70 Allara Street, City, Canberra, ACT

Vipac has conducted a preliminary review of the concept design of the development at 70 Allara Street, Canberra, ACT in regard to the likely wind environment at ground level and adjacent areas to the development. Plans were provided to Vipac in March 2022 and the interaction of the wind with the proposed design was then assessed. Taking into account the wind climate at the site (see Figure 1) and the surrounding developments. No detailed analysis has been conducted at this stage. Vipac recommends that a wind tunnel test be conducted to determine the wind levels at ground level in the detail design stage to confirm our predictions.

Figure 3: Ground Floor Plan of the proposed development

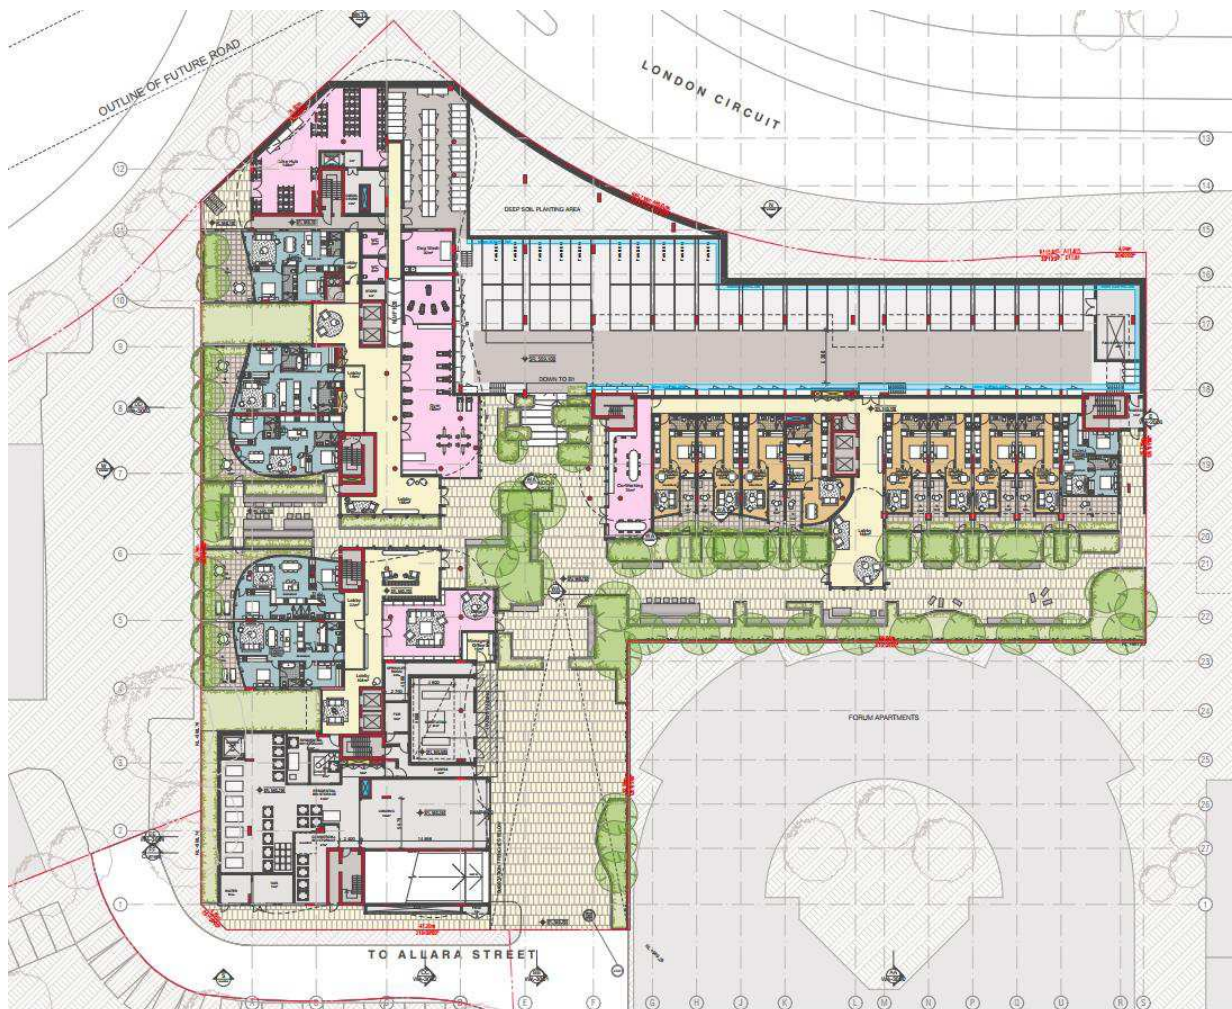
Direct winds from west and northwest could create uncomfortable wind conditions at the outdoor seating areas of Building B. Funnelling winds causing adverse effects are expected at the pedestrian thoroughfare between the three buildings. Additionally, the squared corners of Building 1 may cause some adverse corner accelerations at the building corner.

- Sunken outdoor seating area that is shielded by a >1.5m high landscaped wall and windscreens (Figure 3).
- Extensive landscaping at strategic locations to reduce funnelling and corner acceleration effects (Figure 3, Figure 4).

With these features, the publicly accessible areas are expected to be within the recommended walking comfort criterion; main building entrances are expected to be within the recommended standing comfort criterion; and the alfresco dining areas at the café are expected to be within the recommended sitting comfort criterion.
